PRODUCT NOTICE

Powerline Airway Ribbed Hose Replacement

Fig. 1 - Powerline Airway

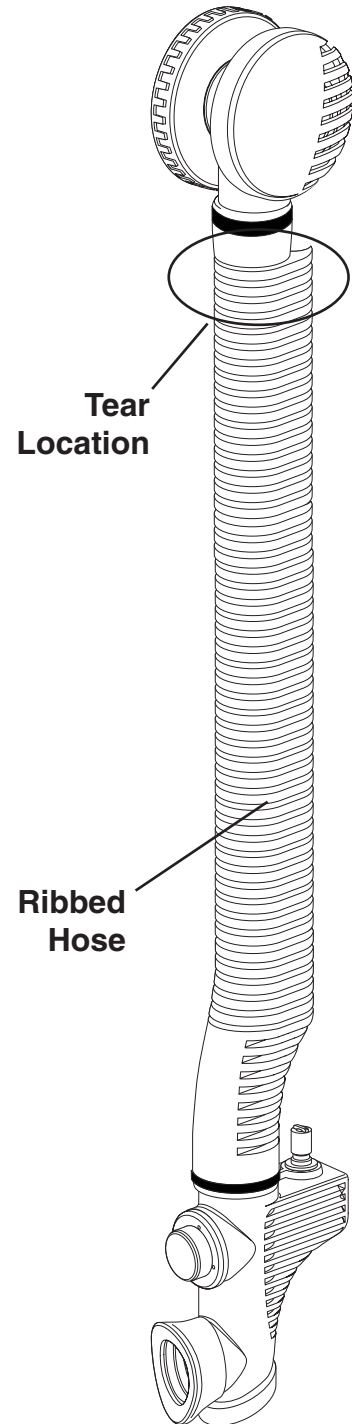
Aqua Lung has received reports that some of the ribbed hoses (Fig. 1) on the Powerline Airway have been tearing at the top near the dual exhaust valve. The problem has been traced to an error in the molding process from our supplier that occurred over a three-month period between 2001 and 2002. The best way to confirm whether or not you have one of the questionable hoses is to look at the serial number on the lower unit of the Powerline (fig. 2). If the serial number falls within the range of **M48H to M52H** (*M48H, M49H...M52H*), or **M01I to M08I** (*M01I, M02I...M08I*) and is the original hose, then it should get replaced. This affects both SeaQuest and Aqua Lung BCs utilizing the Powerline inflator.

If the ribbed hose were to tear near the top, the BC would not be able to hold air and a loss of buoyancy would occur. This could result in the need for the diver to ditch their weight pockets or rely on their buddy for assistance. In extreme cases it could result in result in panic, injury or death.

If you have a spiral hose that falls within the serial number range, please have the hose replaced by this authorized Aqua Lung retailer.
